Access Compliance Report Public Rights-of-Way (Curb Ramps)

Main Street: SUTHERLAND_DR Cross Street: STERLING_GLEN Location: SW

ADA ID: RPRK211109120845 Ramp Type: Type 4 - Parallel Initial Pass/Fail: Fail Overall Compliance: No Severity Score: 30

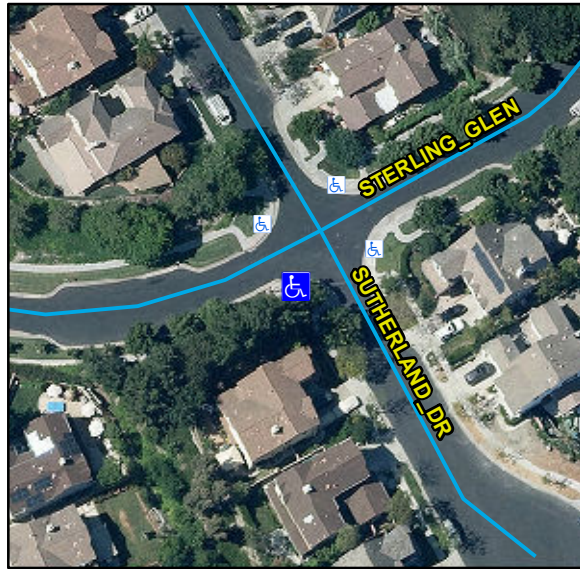
Remove & Replace Curb Ramp With Two New Directional Ramps or Equivalent.

R204.3, R304.3.2, STD 1115
